# DEVELOPMENT REVIEW BOARD REPORT

**15-DR-2005**  
**New Horizon**

Request approval of the site plan and elevations for a five building, professional office complex.

## **Stipulations for Case: New Horizon Case 15-DR-2005**

A-0.1

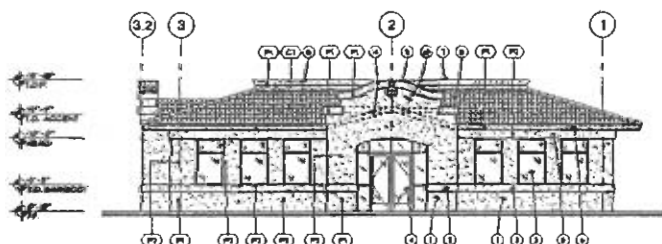
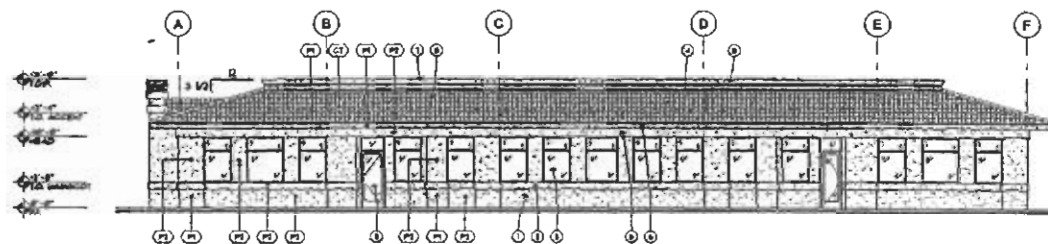
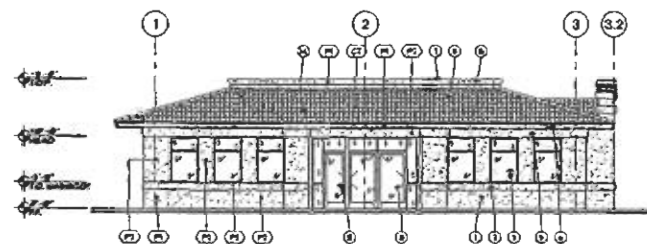
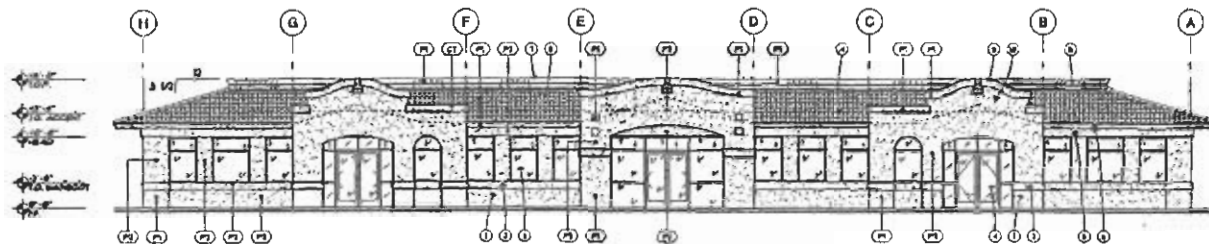
27. The location and configuration of all site improvements shall be constructed to be consistent with the site plan sheet A-0.1 submitted by Archicon, L.C. with a staff receipt date of 5/6/2005, modified per the following stipulations, specifically for the location of the trash enclosures and the sidewalk along the south property line.

40. The refuse enclosure location shown on the 15-DR-2005 DRB site plan dated 5-06-2005, prepared by Archichon, will not provide enough backing distance for the refuse trucks. Move the refuse enclosures to the east so that 40 feet of vehicle length can be provided.
